Re: County: Queens Block: 11087 Lot: 39
Location: 99-10 215th St
Approval No (#): 19080363 Device(s): 1

DEPARTMENT OF ENVIRONMENTAL PROTECTION - BUREAU OF WATER AND SEWER OPERATIONS
APPLICATION FOR APPROVAL OF BACKFLOW PREVENTION ASSEMBLIES

Project: 99-10 215TH STREET
QUEENS, NEW YORK

Title: BACK FLOW ASSEMBLY
SUBMITTAL TO CCCU

Date: 06-03-19
Job No.: 19-0326
Drawn By: MA
Checked By: CMS/FTK
DWG NO. BFP-1
1 of 2

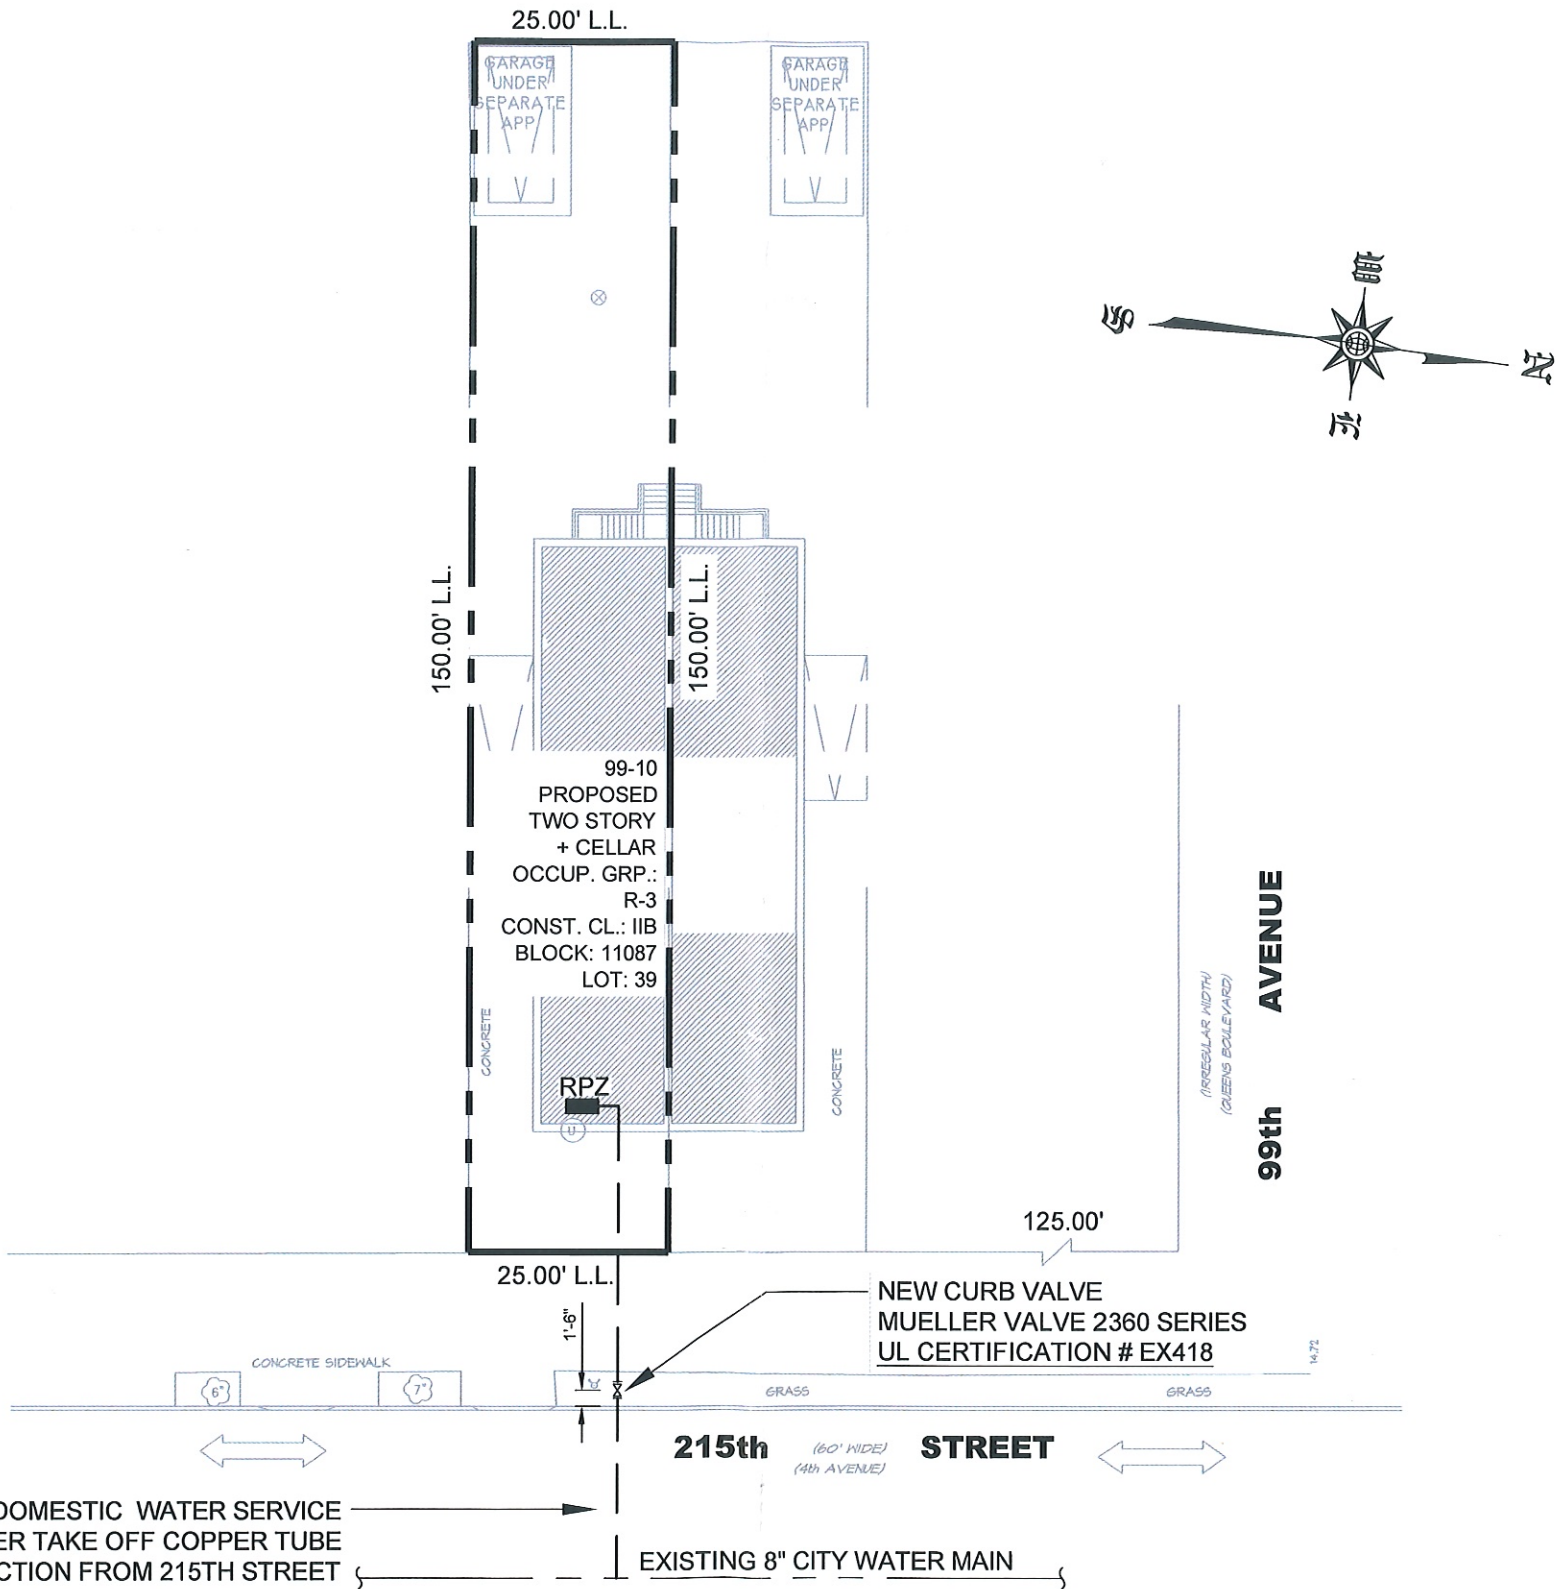
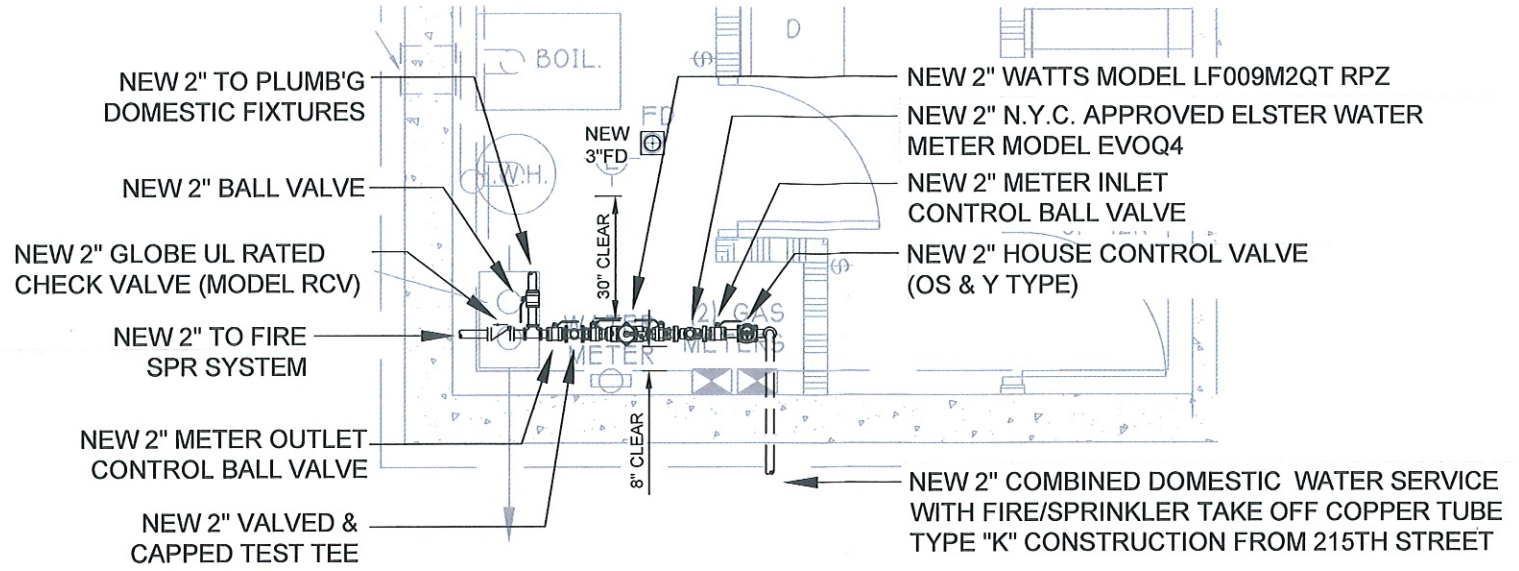
This APPROVAL for
Back flow Device ONLY
NOT for Water Service Connection

Metering Requirements Should be
obtained from the Bureau of
Customer Services
